LEGE
 SITE GRADING & DEVELOPMENT WORK
 SITE GRADING & STORM DRAINAGE PLAN
 DATE JULY 7, 1969
 DRAWN 6676
 DWG. NO. **56-16**
 JOB NO. 67-1-M

SOLANO COUNTY JUNIOR COLLEGE
 SOLANO COUNTY JUNIOR COLLEGE DISTRICT
 ARCHITECT OWNER CONTRACTOR

SITE GRADING & DEVELOPMENT WORK
SITE GRADING & STORM DRAINAGE PLAN

DATE: JULY 1, 1969
DRAWN: DWG
SD-2
JOB NO. 67-1A

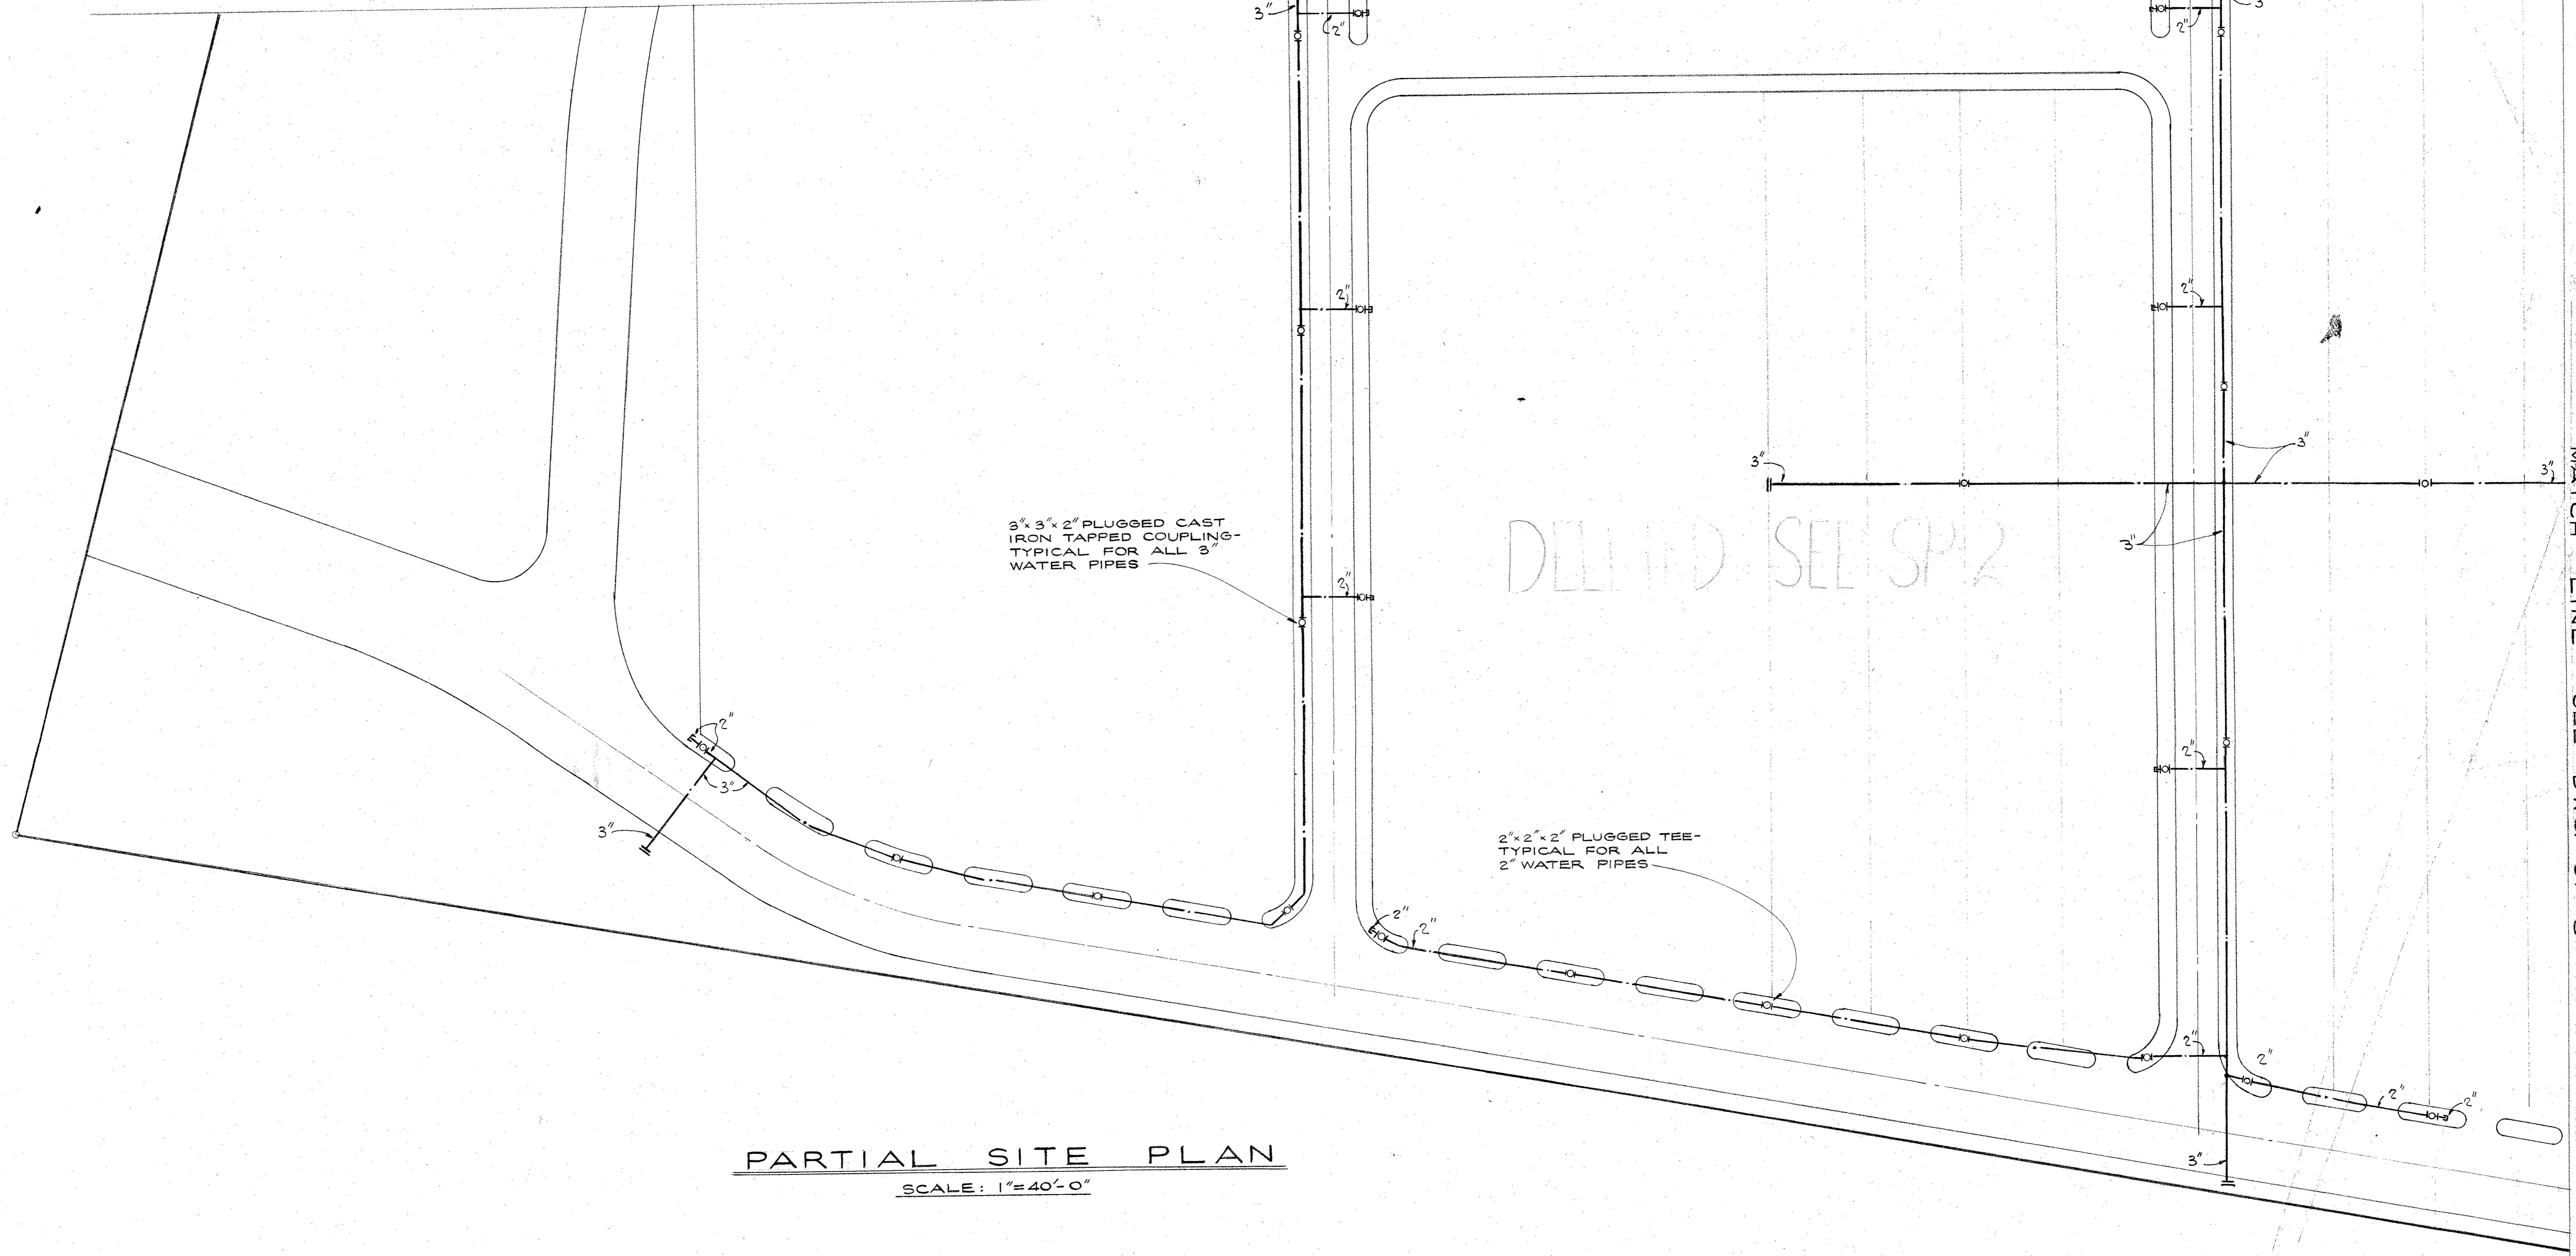
On Drawing SD-2, omit all references to thickness of rock base. Thickness of rock base required for each detail on SD-2 shall be as shown on Plans SF-11, SF-12, SF-13, RSC-14, RSG-15, SC-16, SG-17, SG-18 and SG-19.
